Project	IEEE 802.16 Broadband Wireless Access Working Group < http://ieee802.org/16 >	
Title	Frame Structure to Support Relay Node Operation	
Date Submitted	2006-11-17	
Source(s)	Chenxi Zhu Fujitsu Laboratories America Inc Dorin Viorel Fujitsu Microelectronics Canada Inc Michiharu Nakamura Fujitsu Laboratories Japan	Voice: 1-301-4860671 E-mail: chenxi.zhu@us.fujitsu.com
	Wen Tong, Mo-Han Fong, Peyng Zhu Nortel	Voice: 1-613-7631315 E-mail: wentong@nortel.com
	Jaeweon Cho, Changyoon Oh Samsung Electronics	Voice: 82-31-279-5796 E-mail: jaeweon.cho@samsung.com
	Kanchei(Ken) Loa Heng-Iang Hsu Institute for Information Industry	Voice: +886-2-27399616 E-mail: loa@nmi.iii.org.tw
	Raekesh Taori Samsung AIT	Voice: +82-31-280-9635 E-mail: rakesh.taori@samsung.com
	Adrian Boariu Nokia	Voice : +1-817-5017584 E-mail : adrian.boariu@nokia.com
	Qu Hongyun, Cancan Huang ZTE Corporation	Voice : +86-755-26776604 E-mail : qu.hongyun@zte.com.cn

Frame Structure to Support Relay Node Operation

Figure xxx Example of minimum configuration for an in-band non-transparent relay frame structure

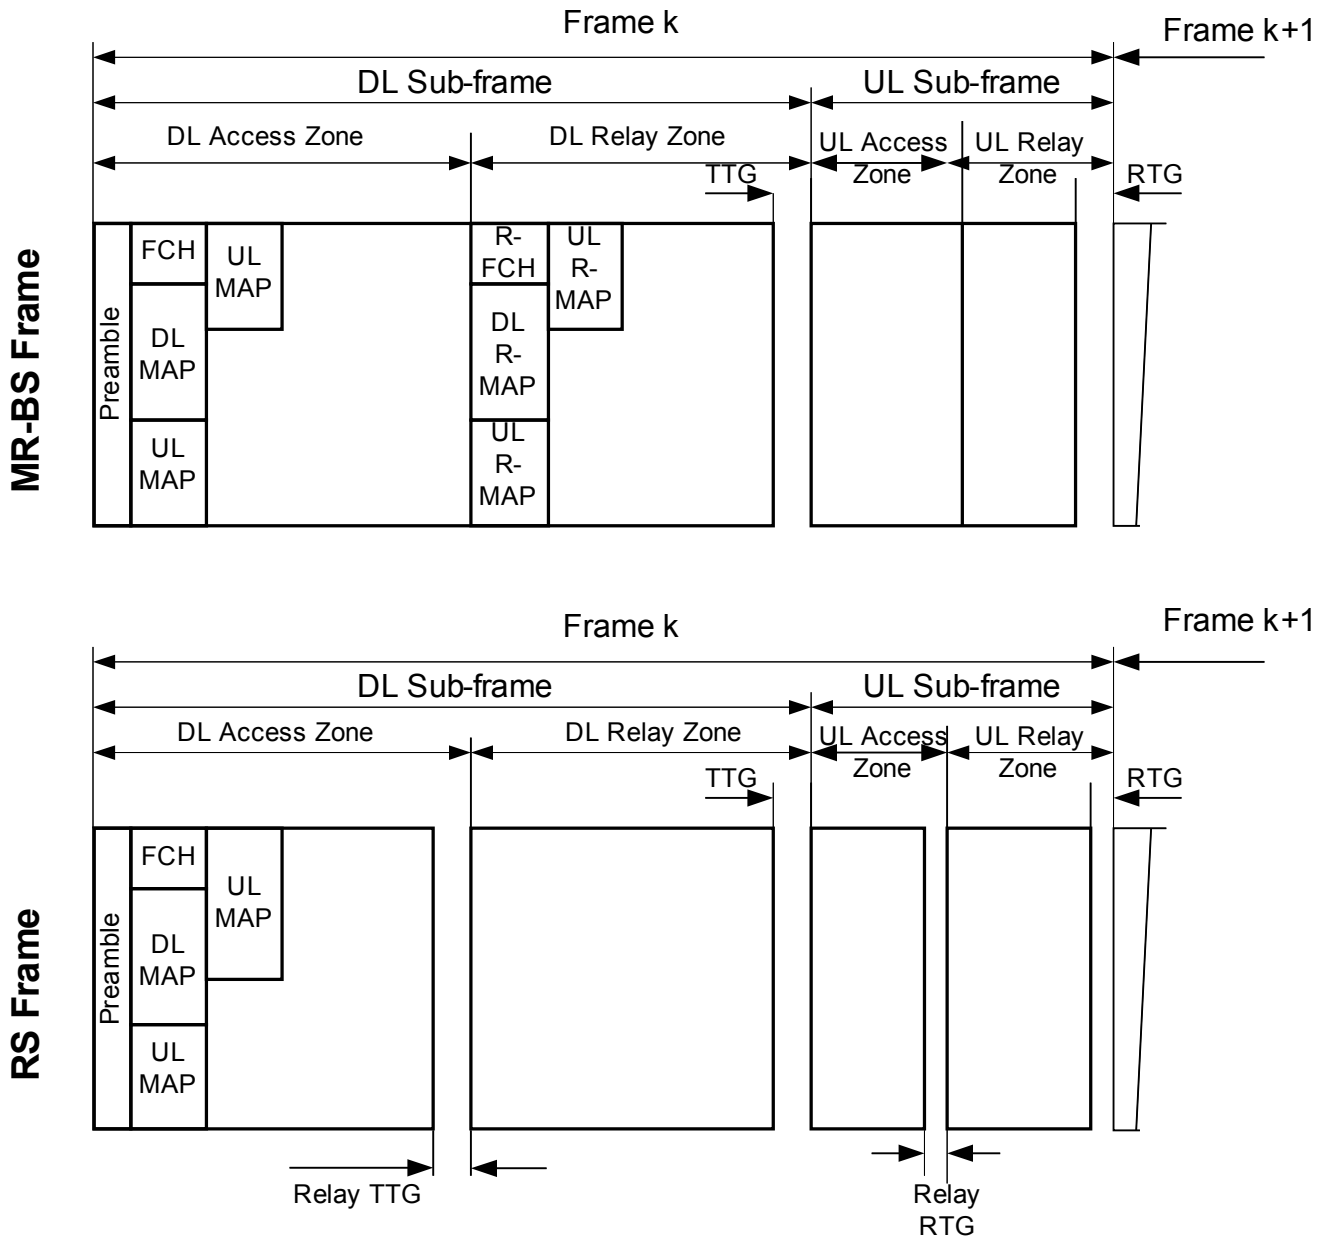
For the TDD mode, an example of the MR-BS frame structure is shown in Figure xxx.

Each MR-BS frame begins with a preamble followed by a FCH and the DL MAP and possibly UL MAP. The DL sub-frame shall include at least one DL Access Zone and may include ~~at least~~ one or more DL Relay Zone(s). The UL sub-frame may include ~~include at least~~ one or more UL Access Zones and it may include one or more UL Relay_Zones. In each frame, the TTG shall be inserted between the DL sub-frame and the UL sub-frame. The RTG shall be inserted at the end of each frame. In the DL Access Zone, the subchannel allocation, the FCH transmission, and the FCH shall be defined as in Section 8.4.4.2.

The DL Relay_Zone shall include a R-FCH and a R-MAP. In the DL Relay Zone, the subchannel allocation may be the same as that in the DL Access Zone. The R-FCH may be the same as the FCH in the DL Access Zone. Other attributes of the MR-BS frame and the RS frame such as transition between modulation and coding, presence of multiple zones, may be the same as those described in 8.4.4.2.
